EVALUATION
OF **RETURN TO REACTOR DOCKET**
FILES
PRESTRESSED TENDON FORCES

ROBERT E. GINNA
NUCLEAR POWER STATION

GAI REPORT NO. 2074

NOVEMBER 20, 1979

**FIGURE 3
PREDICTED TENDON LOSSES
(BASE VALUES)**

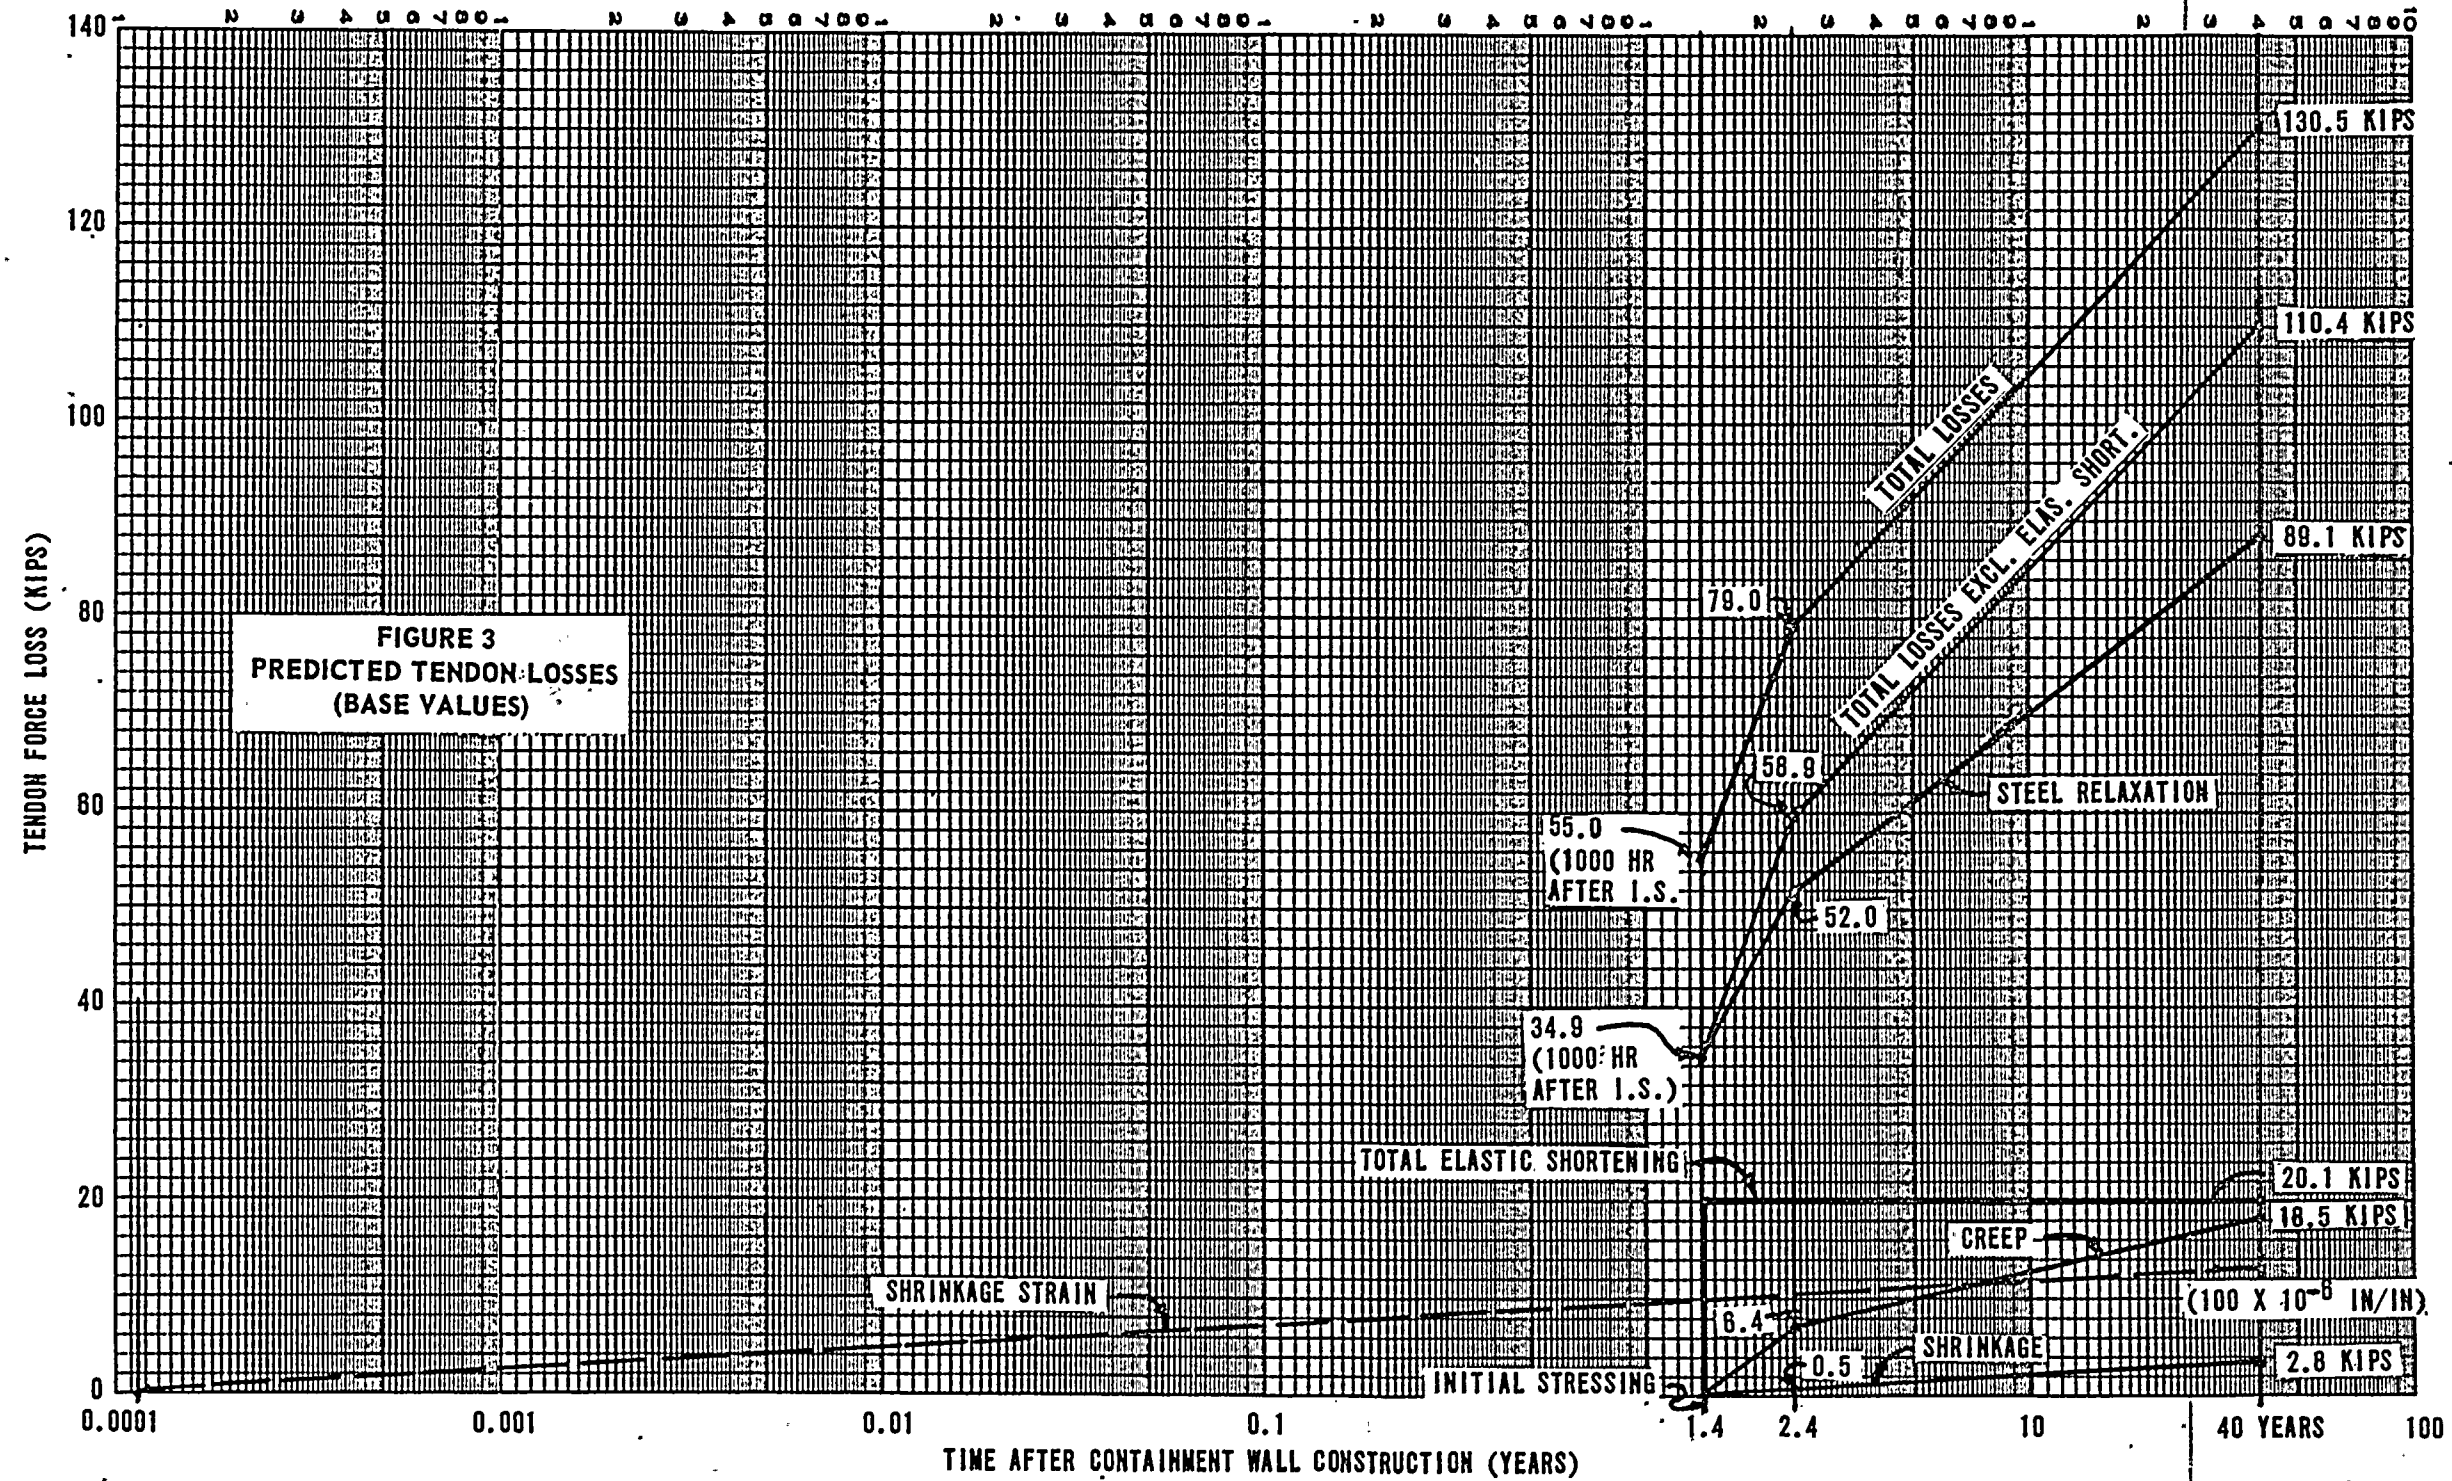
The relaxation loss is zero at $t = 1.41$ years after concrete placement and varies with $\log t$ as shown in Figure 3. Note that 39% of the steel relaxation has occurred by 1000 hours and 58% has occurred by 1 year after stressing. Reference 5 allows a variation of $\pm 15\%$ in the predicted values.

The tendon force losses are plotted over the 40 year plant life in Figure 3. These are the "base values" in the terminology of Reference 5. Applying the percentage variations to the individual losses results in the Upper and Lower Bound values.

FIGURE 3A
STRESS RELAXATION
12% WIRE

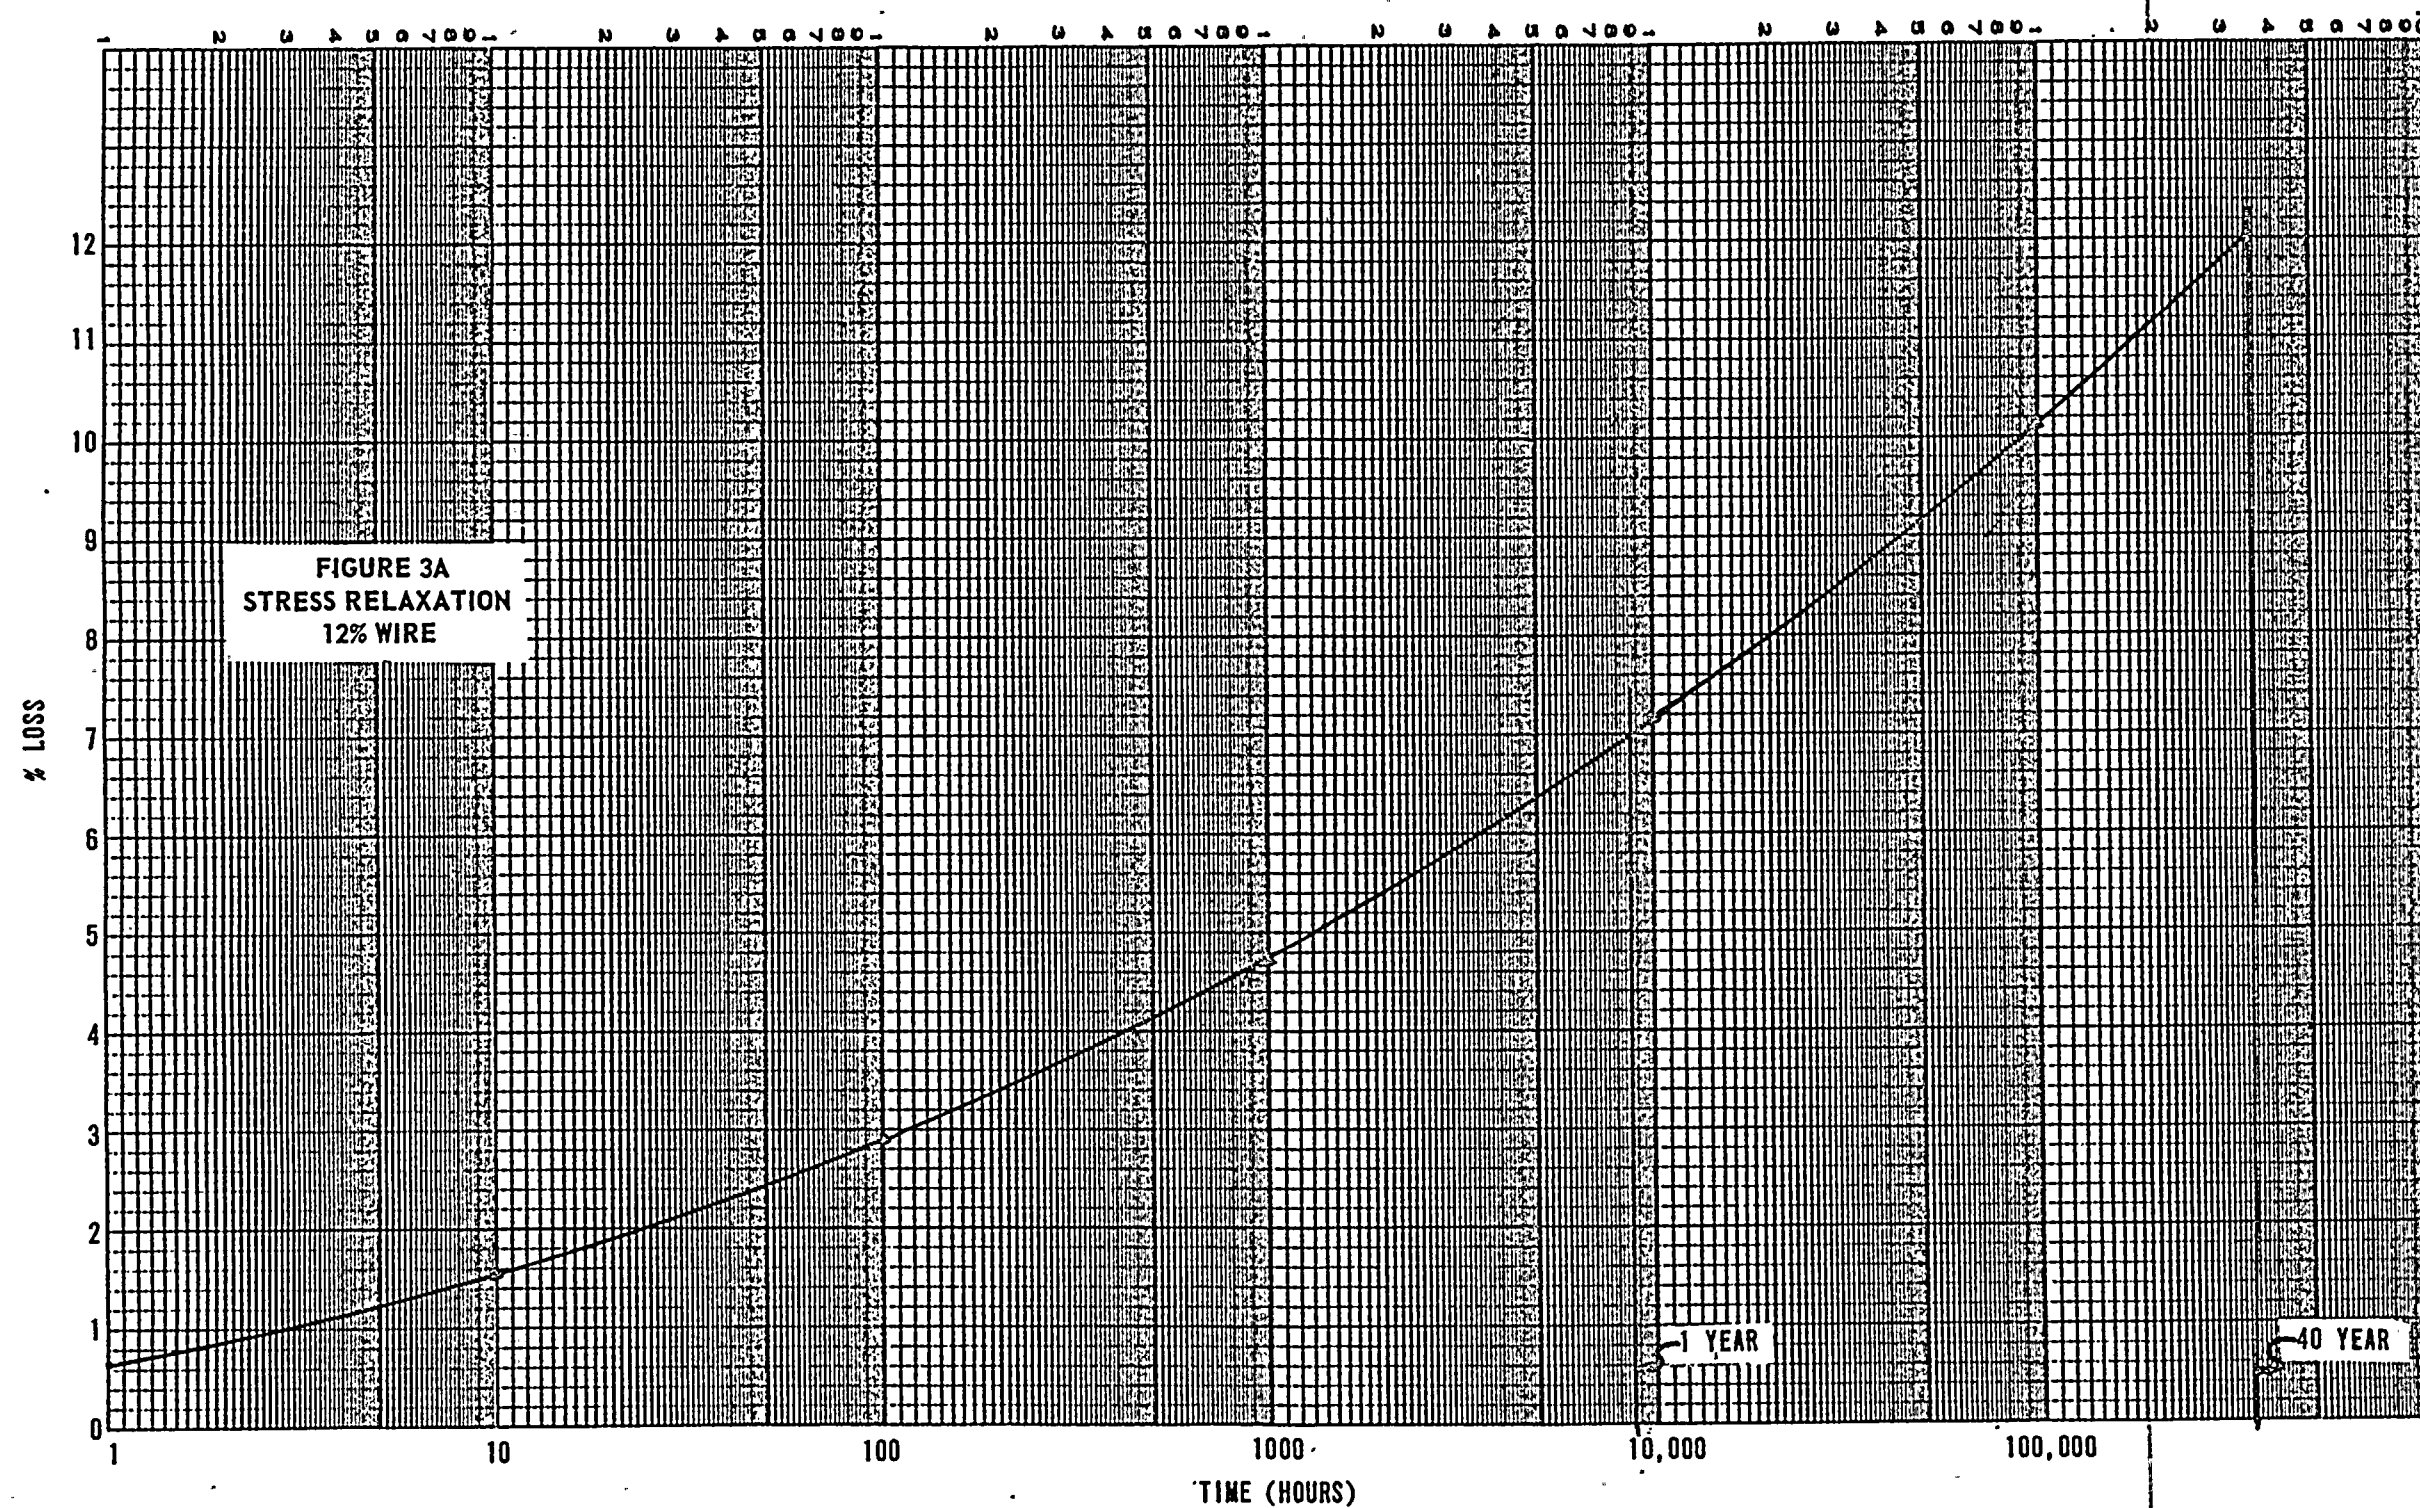
The tendon wire material conforms to ASTM A 421-65, Type BA, and is estimated to have a 40 year stress relaxation of 12%. A typical stress relaxation curve for 12% wire was obtained from the supplier of the original wire, and was used for the loss calculations (Figure 3A). From this curve, losses at 1000 hours, 1 year, and 40 years after initial stressing are:
